**Government of the People's Republic of Bangladesh
Energy and Mineral Resources Division
Hydrocarbon Unit**

Review of “Techno-Economic Feasibility Study”

Khalashpir Coal Mine

Final Report

Figure 4-1 Configuration of a Top Coal Caving Longwall

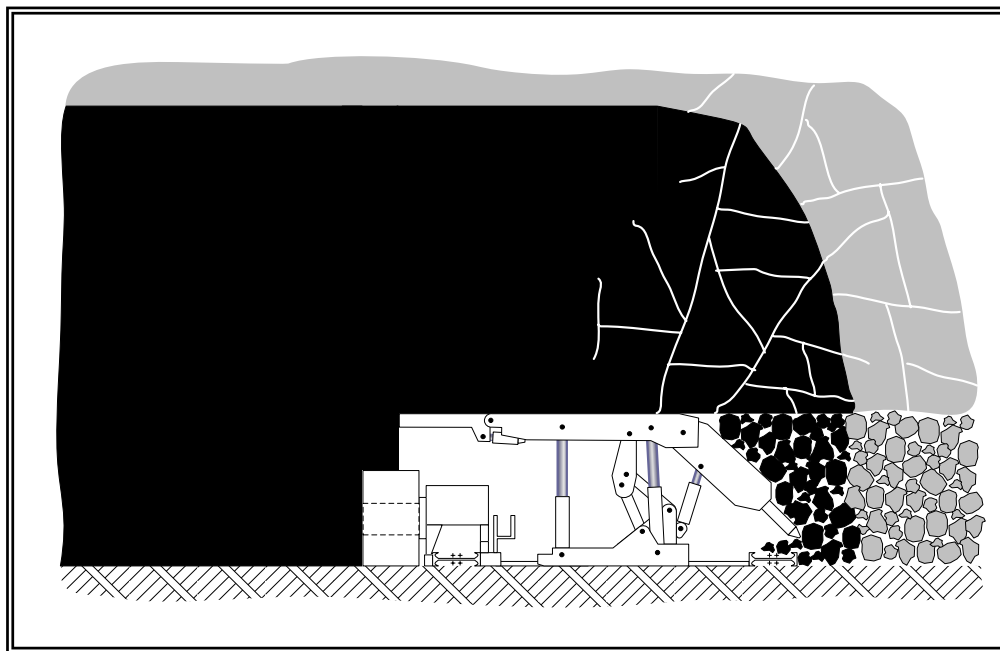
IMC would recommend the use of top coal caving longwall faces extracting a controlled coal thickness commensurate with a maximum aquifer base strain of 10 mm per metre, as shown in Figure 4-1 below. This approach could address the issues of numbers of operational longwall units, overall production rate and continuity, as a single face mine, but needs to be part of a detailed integrated Life of Mine (LOM) plan.

Figure 4-6 Coal Process Design Steps

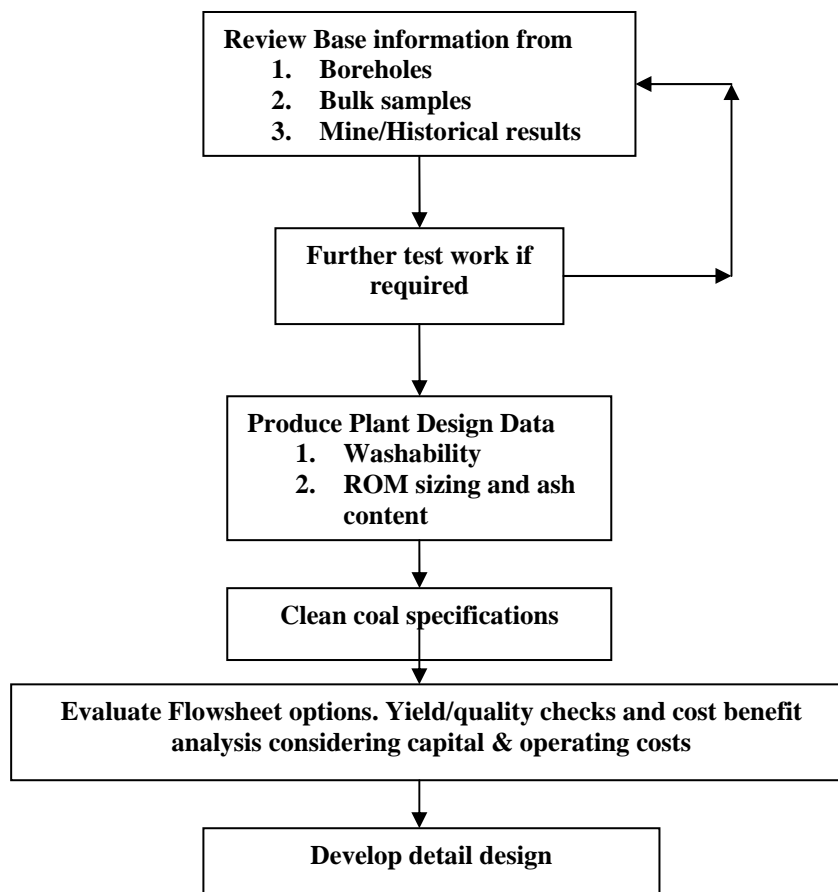
IMC considers that almost certainly some form of coal preparation will be required, which will be dependent on the saleable production products and their specifications.

Figure 4-6 below shows the basic coal process design steps that IMC recommends should be employed in the Project.

Figure 5-1 Location of Surface Facilities

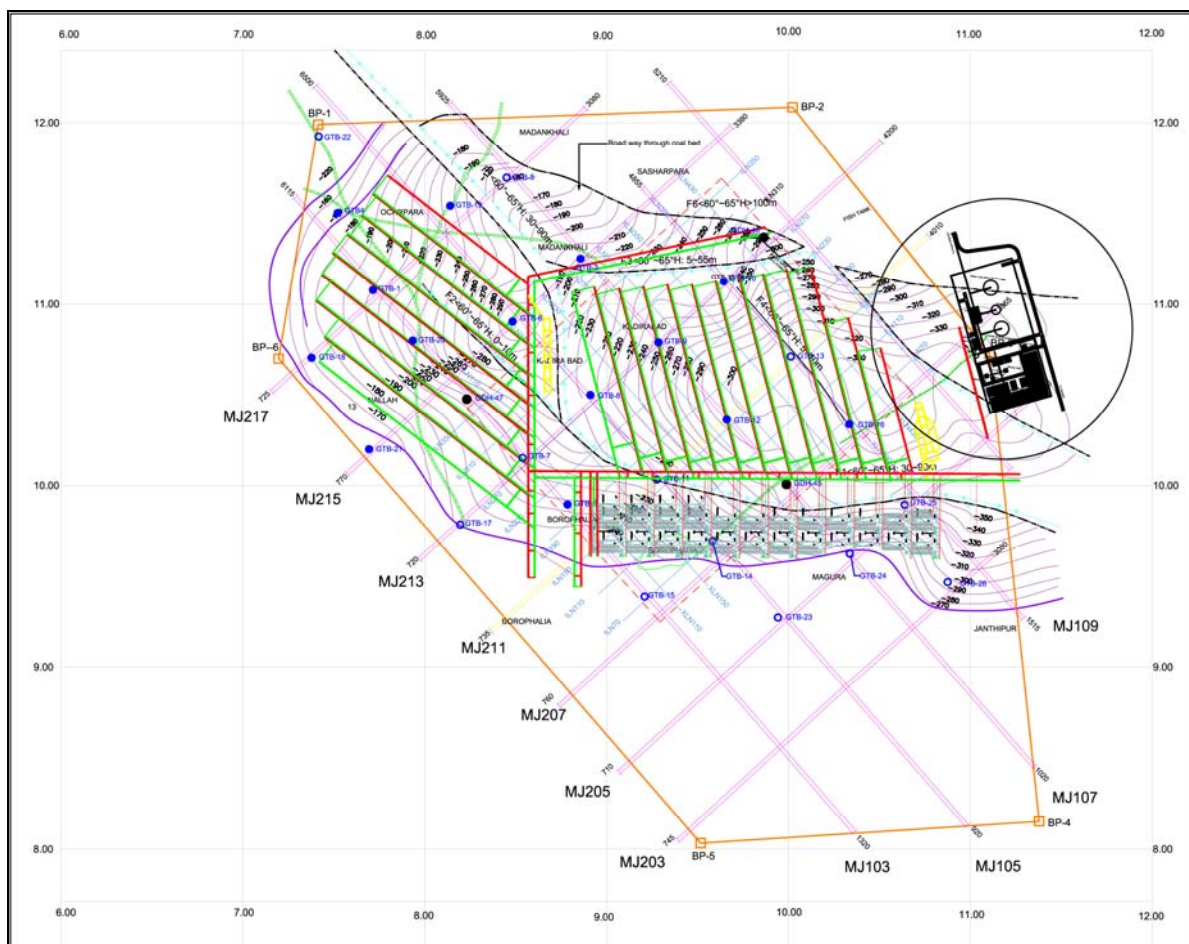
The FS proposes access to the mine to the NW of the deposit. From a surface design perspective this location only has the advantages of being closure to the main drainage outfall in the area. However, due to overriding underground considerations as described in the mining section of this report IMC recommends access on the eastern boundary of the resource as shown in Figure 5-1 below.

The FS proposes access to the mine to the NW of the deposit. However, due to overriding underground considerations as described in the mining section of this report IMC recommends access on the eastern boundary of the reserve as shown in Figure 5-1.

Figure 5-2 Surface Layout

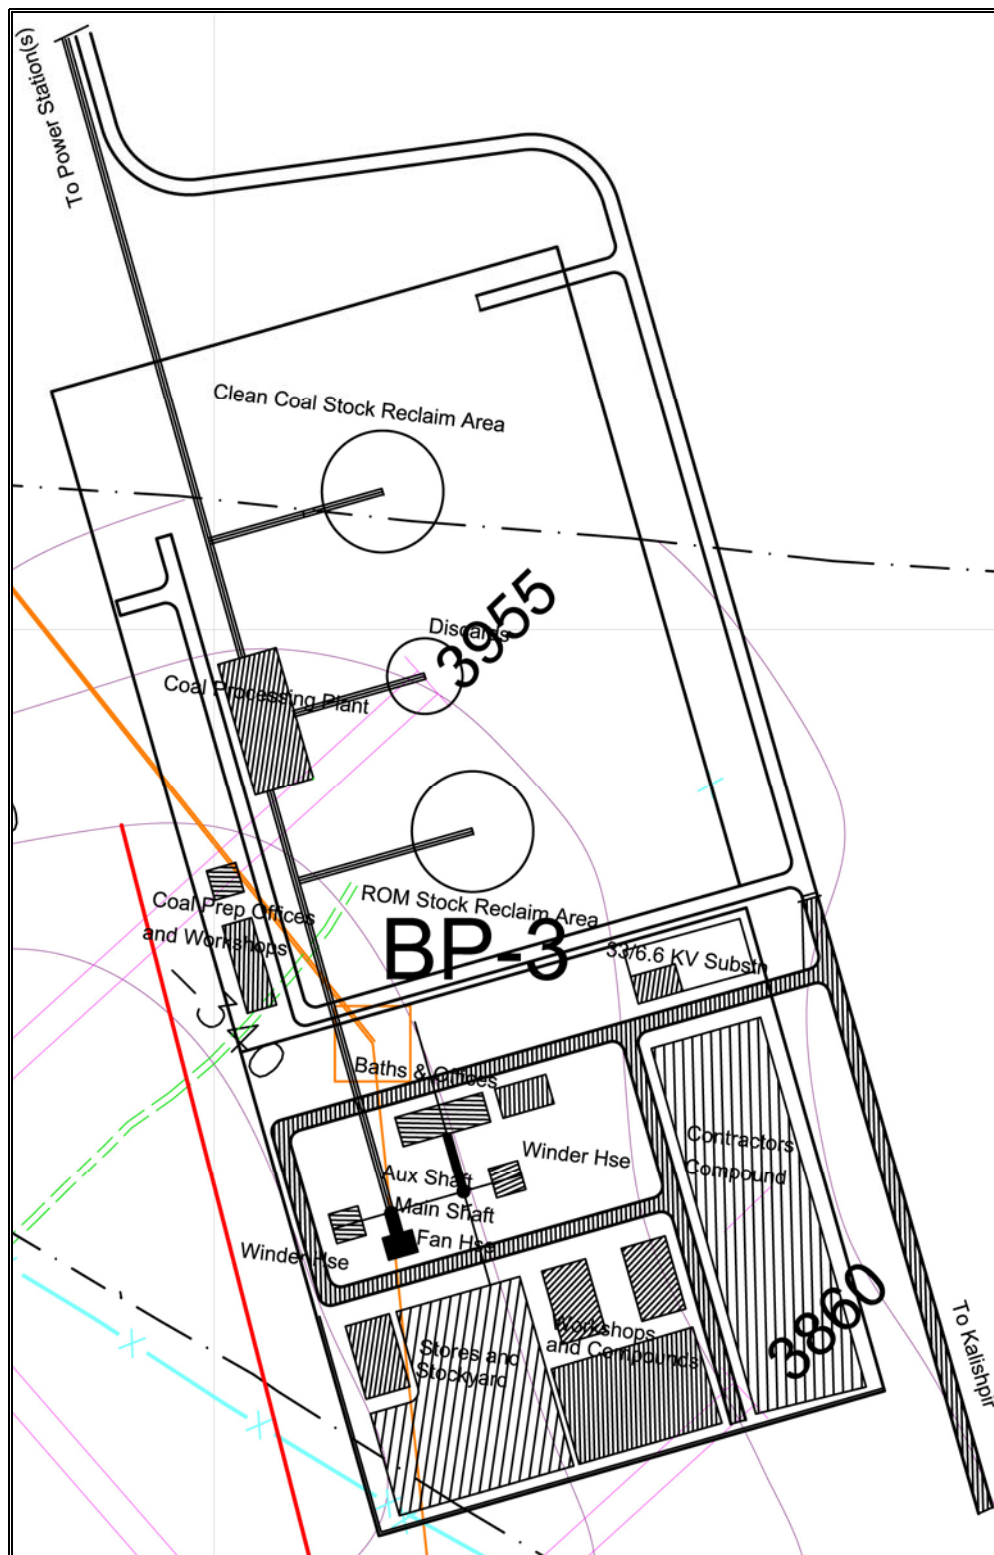
IMC has prepared a conceptual sketch layout is provided in Figure 5-2 below to solely illustrate the principle design consideration to be addressed at the next stage of project development. The final site layout will depend on additional geological and mining investigation during the next phase of project development.
